Parts & Accessories Bulletin

PAB #517

REPLACEMENT CYLINDER STUDS FOR XLH & 1340cc ENGINES

Figure 2. New Cylinder Studs.

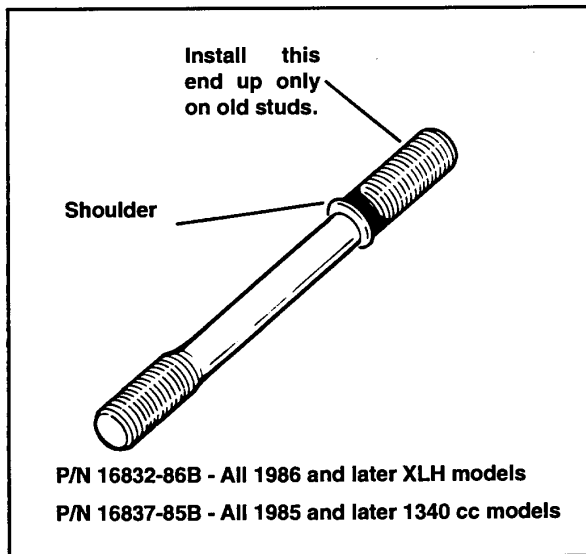
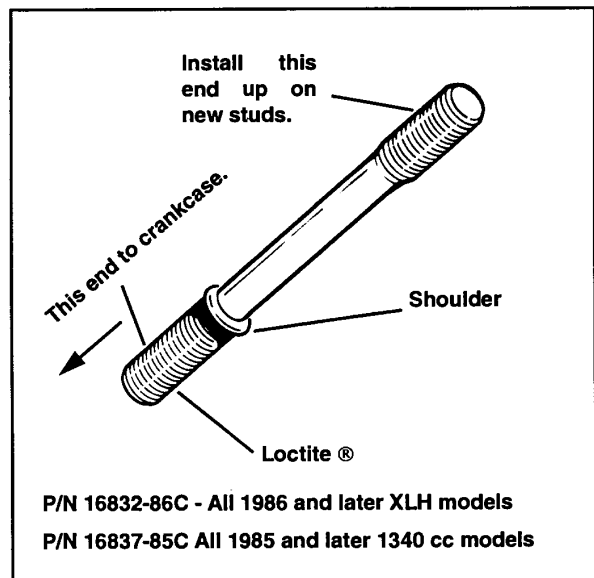
This bulletin is to inform you of the changes made to the cylinder studs. **The new studs no longer provide an interference thread fit with the crankcase tapped holes.** See Figures 1 and 2. Figure 1 shows the old cylinder stud, and Figure 2 shows the new stud.

See Figure 2. The new studs may be identified by the Loctite® applied to the first 6 - 8 threads on the shouldered end of the stud.

The new studs must be installed with the shoulder end down. Thread shouldered end into crankcase and tighten to 10 ft-lbs (13.6 Nm) torque.
